## FAQ Title NFPA 805 Monitoring

**Plant:** Harris Nuclear Plant  
**Contact:** Joelle DeJoseph/ Dave Miskiewicz  
**Date:** February 10, 2012  
**Phone:** 919-546-6247  
**Email:** [joelle.dejoseph@pgnmail.com](mailto:joelle.dejoseph@pgnmail.com)

The purpose of this FAQ is to clarify the following for the NFPA 805 monitoring program:

See revisions to NEI 04-02 Section 5.2.1, Section 5.2.3, and Appendix E below.

### Figure E-1 – NFPA 805 Monitoring Process

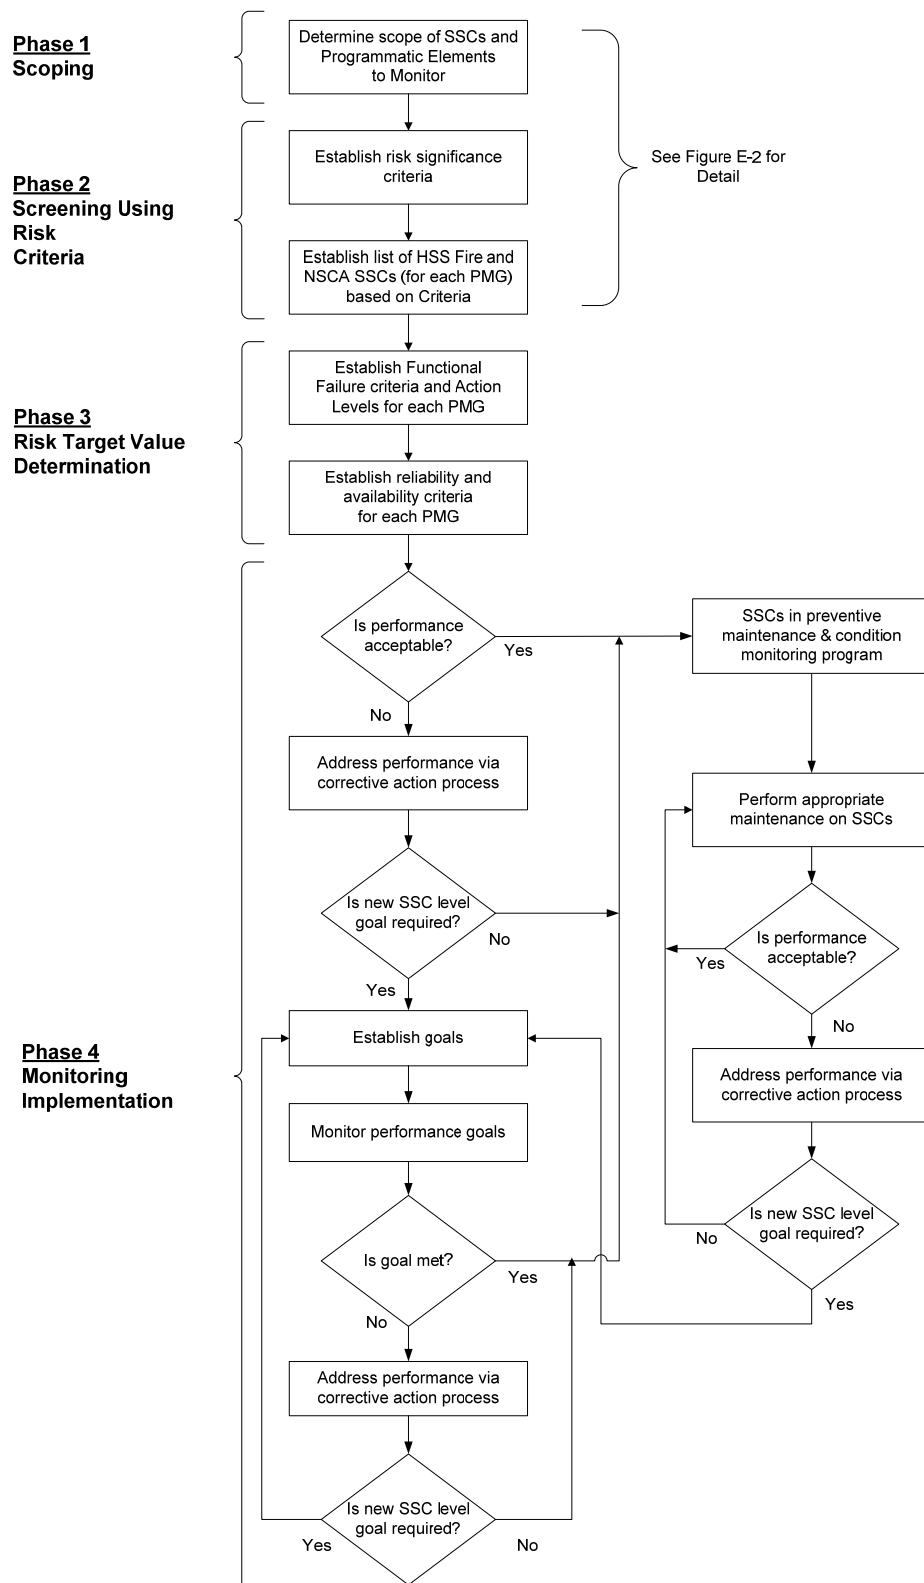
**REPLACE ALL OF APPENDIX E WITH THE FOLLOWING:**

A suggested methodology is outlined below. Figure E-1 provides an overview of the Monitoring Process, while Figure E-2 provides detail on a process for Phases 1 and 2.
